REPORT FOR CONSIDERATION AT PLANNING SUB-COMMITTEE

Reference No: HGY/2013/0485	Ward: Northumberland Park
<p>Address: Brook House, 881 High Road N17 8EY</p> <p>Proposal: Approval of details pursuant to Condition 5 (external design and appearance of the School elevations) attached to planning permission HGY/2012/2128.</p> <p>Existing Use: Vacant land - Former Industrial (Use B1/B2/B8)</p> <p>Proposed Use: Residential (Use Class C3); Education (Use Class D1); Commercial (Use Class B1, D1 & D2)</p> <p>Applicant: Newlon Housing Trust</p>	
<p>Case Officer Contact: Michelle Bradshaw P: 0208 489 5280 E: michelle.bradshaw@haringey.gov.uk</p>	<p>Terry Knibbs P: 0208 489 5590 E: terry.knibbs@haringey.gov.uk</p>
<p>PLANNING DESIGNATIONS: Defined Employment Area – Industrial Location Area of Archaeological Importance Road Network: C Road Adjacent to Conservation Area</p>	
<p>RECOMMENDATION DISCHARGE condition 5 (external design and appearance of the School elevations) attached to planning permission HGY/2012/2128.</p>

DESIGN PANEL FINAL REPORT FOR THE NEWLON GROUP MIXED DEVELOPMENT PROJECT FOR THE CANNON RUBBER FACTORY SITE

ORIGINAL SCHOOL DESIGN – HIGH ROAD EAST ELEVATION (LOOKING WEST)

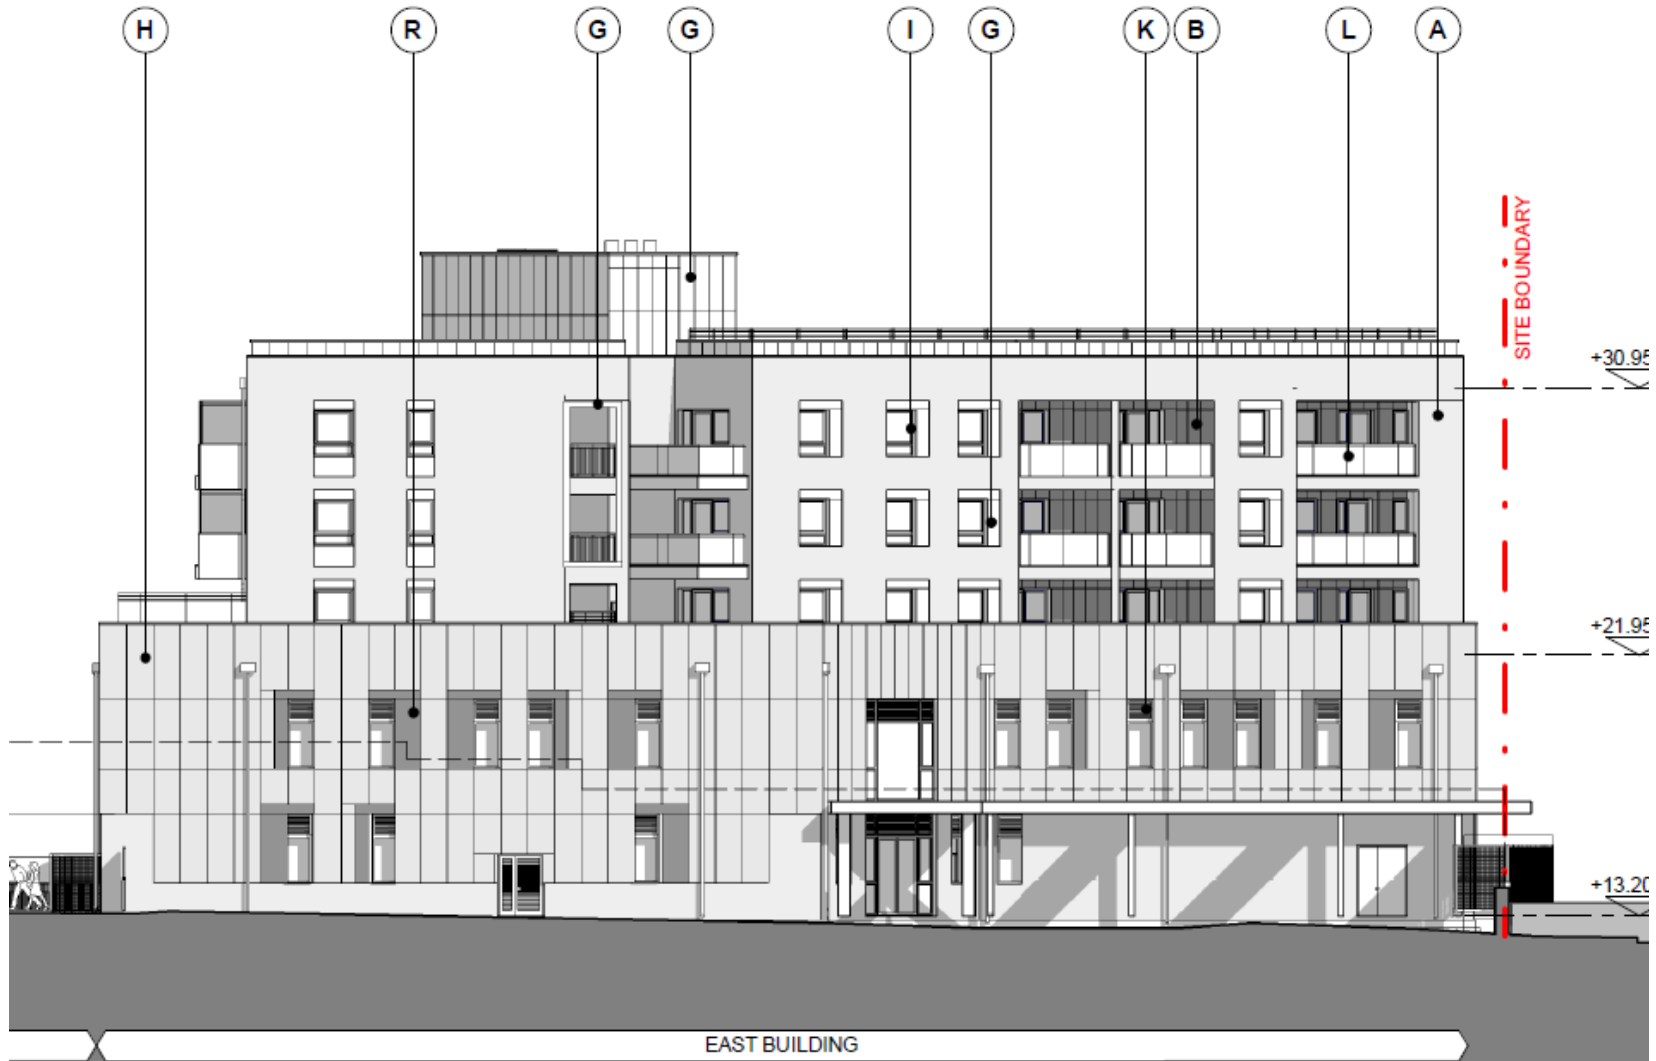
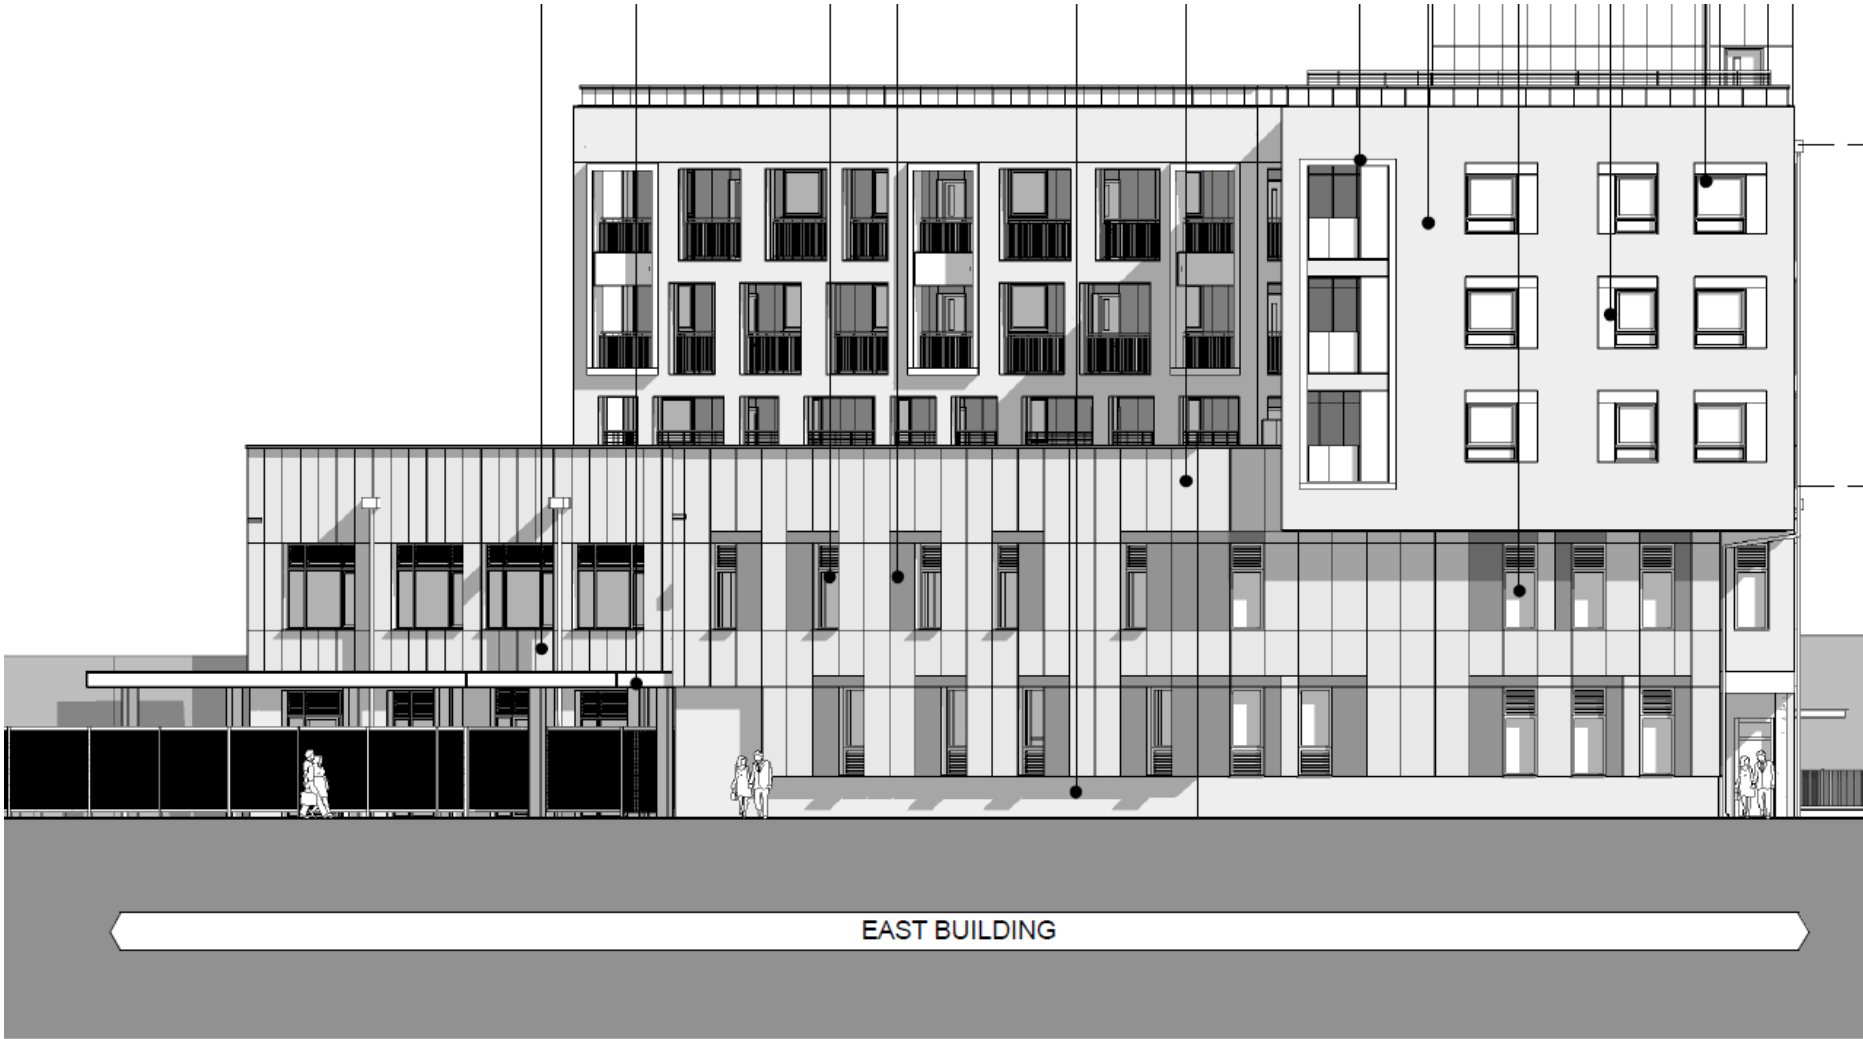
- 8.6 The main changes to the design of the school elevation are summarised as follows:
- The school facades have been made more open and playful by:
- Enlarging window openings

- Varying the panel breakup of the façade
 - Using a simple colour scheme, but introducing a bold colour within the window reveals which ties in with the school's identity

- Adding a brickwork base which steps up and down to express the interior function of the school
 - Opening the concierge to the street for better natural surveillance by reducing the bin store corridor adjacent

- Providing more glazing to the energy centre to allow views in
- 8.7 Following the third and final Design Panel Meeting the proposed design for the school and tower (being assessed under a concurrent application reference HGY/2013/0487) were referred to Paul Finch OBE (former commissioner at

- 8.8 Officers are satisfied that the design changes made to the proposed school facade result in a high quality building and design outcome and meet the requirements of the relevant planning policy set out in the London Plan (2011), Haringey Local Plan (2013) and Haringey Unitary Development Plan (2006).
- 8.9 On this basis, it is recommended that condition 5 (external design and appearance of the School elevations) attached to planning permission HGY/2012/2128) be discharged.
